Goldsboro Road Pedestrian and Bicycle Improvements Study – Facility Planning Phase I

Description

Staff will brief the Planning Board on the Project Prospectus for the Goldsboro Road Pedestrian and Bicycle Improvements project and solicit your comments, which will be considered in MCDOT's preparation of the final document to be submitted to the County Council.

Figure 5: MacArthur Boulevard / Goldsboro Road Intersection

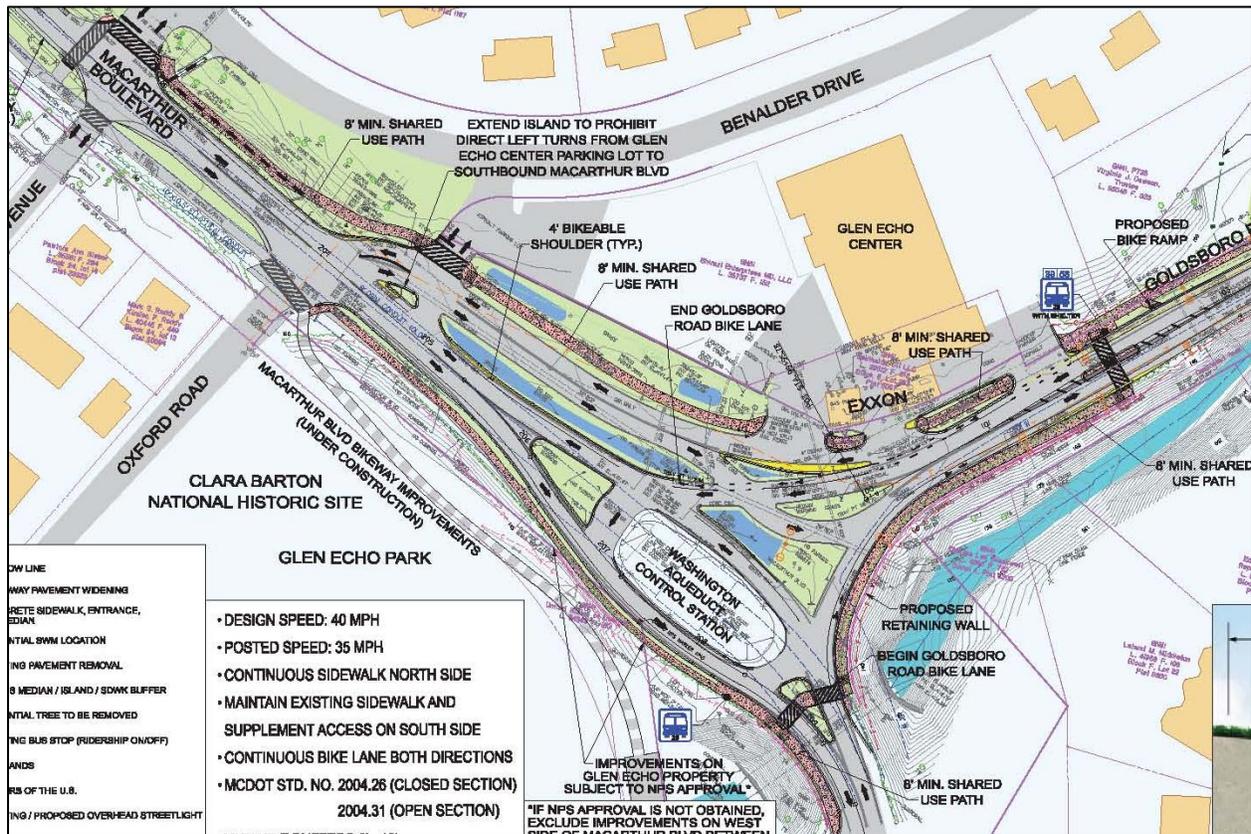
The intersection of MacArthur Boulevard and Goldsboro Road has an unconventional design that functions somewhat like a traffic circle due to the presence of the Washington Aqueduct Control Station, located in the middle of the intersection. The project team evaluated several options for reconfiguring the intersection to simplify pedestrian and bicycle crossing movements, while improving the operation and safety of all intersection users. All of the options were deemed infeasible because each would have routed traffic on top of the existing aqueduct in areas that could be damaged by heavy truck traffic. To accommodate pedestrian and bicycle transitions between Goldsboro Road and MacArthur Boulevard, shared use paths are provided on both sides of Goldsboro Road and connect to crosswalks at MacArthur Boulevard (see Figure 5). This is not ideal, but the constraints at the intersection are beyond the scope of this study to address.

MCDOT adequately addressed most of the comments that Planning staff made during the course of the Facility Planning Phase I study. Therefore, we do not have any additional recommendations for improving the study. However, we do believe that a future facility planning study is needed to further evaluate the unconventional intersection of MacArthur Boulevard and Goldsboro Road.

1. The Goldsboro Road Bicycle and Pedestrian Improvements Study should proceed to Phase II of the facility planning process to develop a detailed design for the completion of the Preferred Alternative (#2).
2. MCDOT should conduct a future facility planning study to further evaluate ways to reconfigure the intersection of MacArthur Boulevard and Goldsboro Road to simplify pedestrian and bicycle crossing movements and improve the operation and safety for all intersection users.

FIGURE 5 | PRE-SELECTION FOR INTERESTED BUT CONCERNED

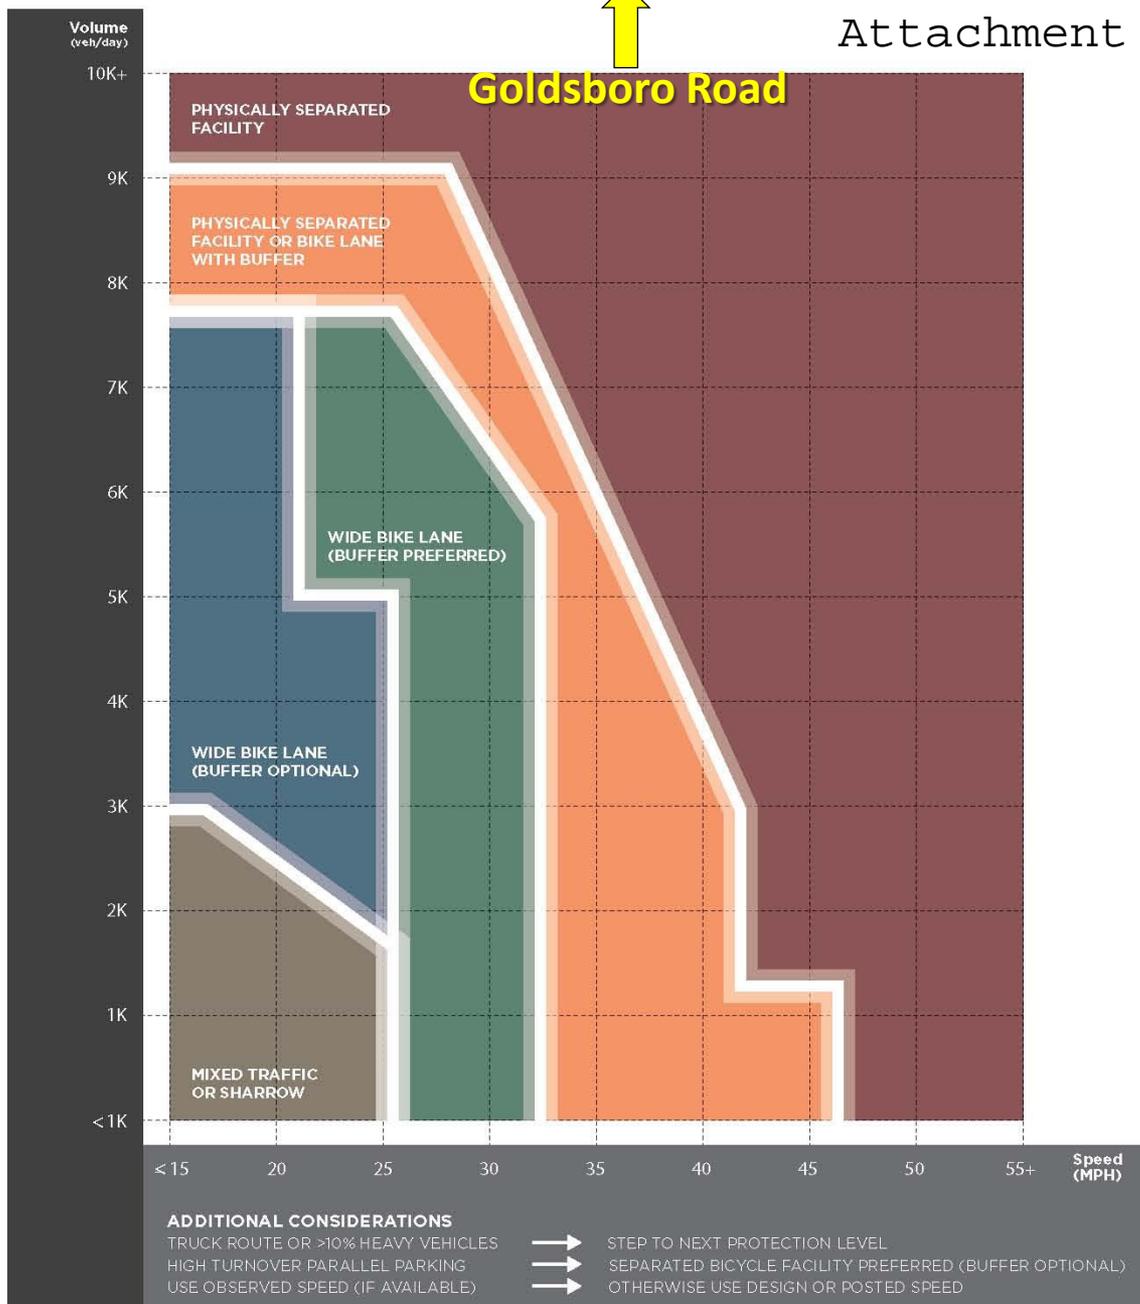
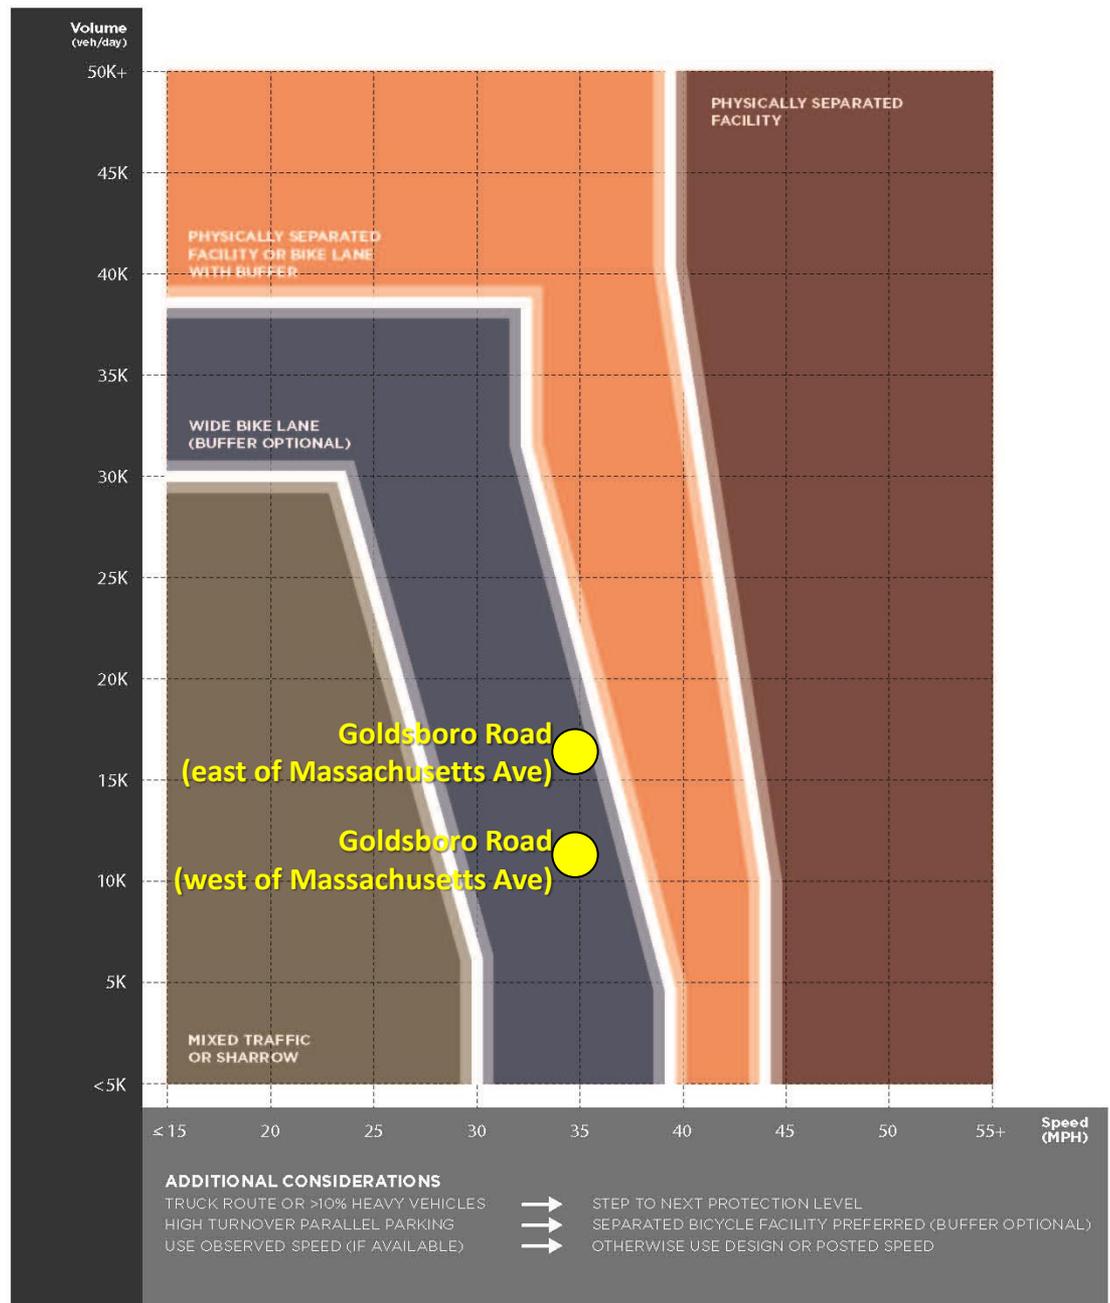
The Bicycle Planning Guidance that the Planning Board reviewed on September 4, 2014 includes two graphs to identify the types of bicycle facilities that are most appropriate under different traffic speed and traffic volume conditions: one graph for “Confident Cyclists” and another for the “Interested but Concerned” population (Attachment 2)¹. Since the posted speed limit on Goldsboro Road is 35 mph; the average daily traffic (ADT) is approximately 11,500 between MacArthur Boulevard and Massachusetts Avenue and is 16,500 between Massachusetts Avenue and River Road, bike lanes are sufficient to address the needs of the “Confident Cyclist” population, but are likely insufficient to meet the needs of the “Interested but Concerned” population, who would prefer a physically separated bicycle facility, such as a cycle track or a shared use path, to ride comfortably on Goldsboro Road. However, either facility type would require additional paved areas and will increase the environmental impacts adjacent to a tributary.
